April 9, 2003  
LIC-03-0053

**SUBJECT: Response to Request For Additional Information (RAI), Related to Exemption Request from the Requirements of 10 CFR 50, Appendix R, Section III.G.2 for Room 19 at Fort Calhoun Station (FCS)**

**Response to NRC Request for Additional Information  
For OPPD  
Exemption Request from the Requirements of 10 CFR 50, Appendix R,  
Section III.G.2 for Room 19 at FCS**

ATTACHMENT 2  
PAGE 1  
FORT CALHOUN STATION  
FIRE AREA 32

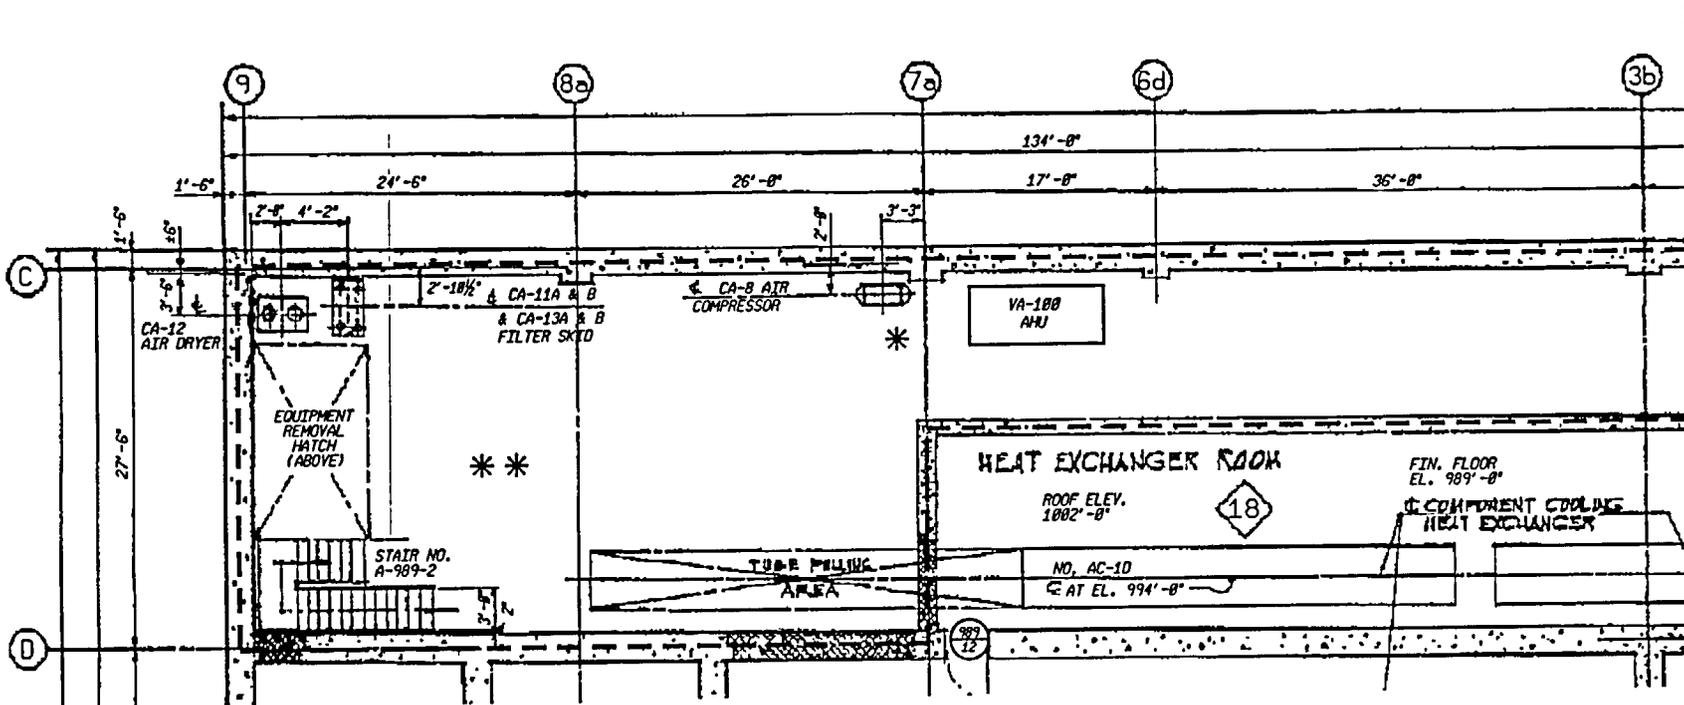
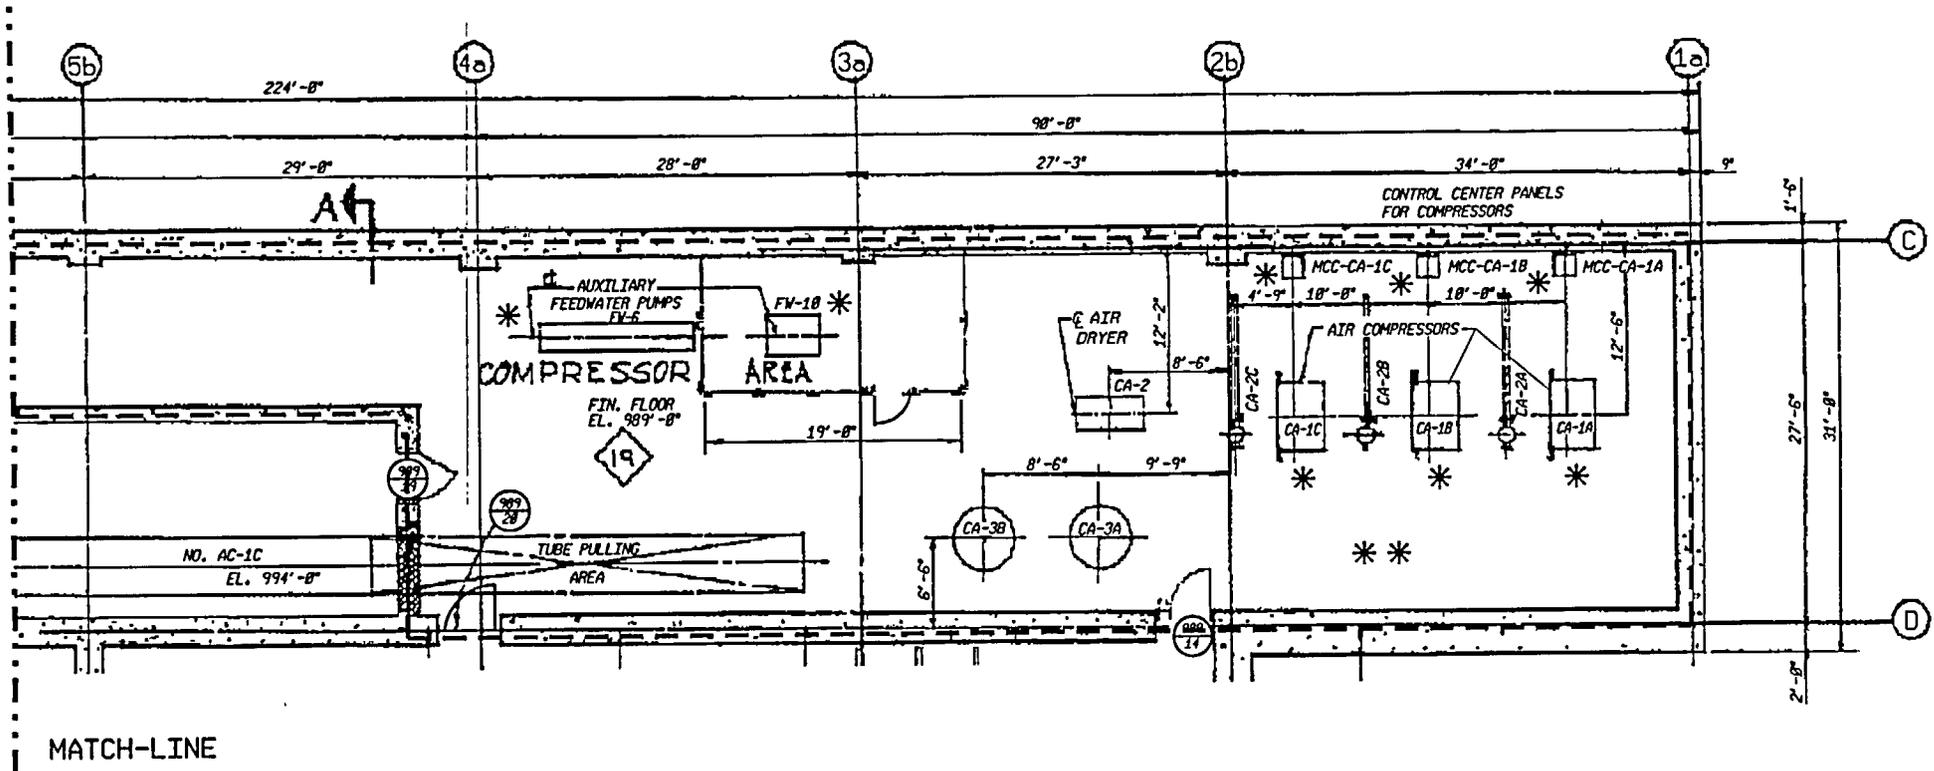
**The 3-dimensional Figure 1 attached in the November 8, 2002, exemption request (exemption request) does not provide the appropriate level of detail for staff review. Please submit a revised drawing (P&ID) which shows the following for Fire Area (FA) 32:**

- **room dimensions (including height),**
- **location of compressors and auxiliary feedwater pumps,**
- **fire doors and fire barriers,**
- **the location of cable trays identified in exemption request (identifying both power and control cables),**
- **ventilation system details, and**
- **locations of any fixed and/or transient ignition sources.**

Refer to Attachment 2 for additional clarification on room dimensions, major equipment locations, fire door and barrier designations, and the location of fixed and potential transient ignition sources. Ventilation for FA 32 is provided by supply and exhaust fans located in a different fire area. Approximately 2,200 cubic feet/minute (cfm) of non-cooled air is provided to the room with ductwork running along the west (supply) from columns 1a to 4a and east (exhaust) from columns 1a to 6d of the area. Approximately 3,400 cfm of cooled air is also provided for the room by air handling unit, VA-100, which is shown in Attachment 2. OPPD requests the NRC refer to the 3-dimensional Figure 1 submitted on November 8, 2002 for location of cable trays identified in the exemption request. This level of detail for the cable trays is difficult to display on plan view drawings and is much better depicted in the 3-dimensional color-coded figure previously submitted. Additionally, OPPD recommends that the NRC refer to the June 27, 2002 Public Meeting Presentation materials (which OPPD provided to the NRC) that depict detailed information within each zone. The Public Meeting Presentation materials contain color-coded cable trays with redundant tray designations, which may be helpful to the reviewers. Finally, OPPD recommends that the reviewers conduct a site visit to inspect FA 32. A site visit will help the reviewers better understand the layout and physical attributes of the fire area.
